Project: IEEE P802.15 Working Group for Wireless Personal Area Networks (WPANs)

Submission Title: [Resolutions for new comments received after May 5 and May 9]

Date Submitted: [May 14, 2008]

Resolutions for new comments received after May 5 and May 9

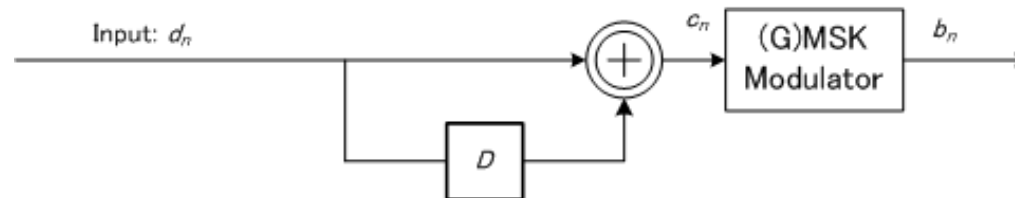
Comment 4 (SC PHY, document modification)

- Figure 189, more description in terms of equations is required to equate $\pi/2$ BPSK modulator and GMSK modulator. For example initial phase of the chip level rotator. Also, the differential operation (xor) as currently specified is incorrect. If g_n is the input to the GMSK modulator then in the real field $g_n = d_n \times d_{(n-1)}$ which is inverse of xor. In general, complete specification through equations would help rule out ambiguity
- **Resolution: Equation shown in the next slide shall be added to equate $\pi/2$ BPSK modulator and GMSK modulator.**

Regarding $\pi/2$ BPSK,
the following equation shall
be added in 12.2.2.1.1

$$c_n = \begin{cases} 1, & \text{if } d_n = 1 \\ -1, & \text{if } d_n = 0 \end{cases}$$

$$b_n = c_n e^{jn\frac{\pi}{2}}, n = 0, 1, 2, \dots$$

Regarding precoded GMSK,
the following equation shall
be added in 12.2.2.1.1

$$c_n = d_{n-1} \otimes d_n$$

$$b_n = b_{n-1} \cdot e^{-j \cdot c_n}, n = 0, 1, 2, \dots$$

$$d_0 = 1, b_0 = e^{-j}$$
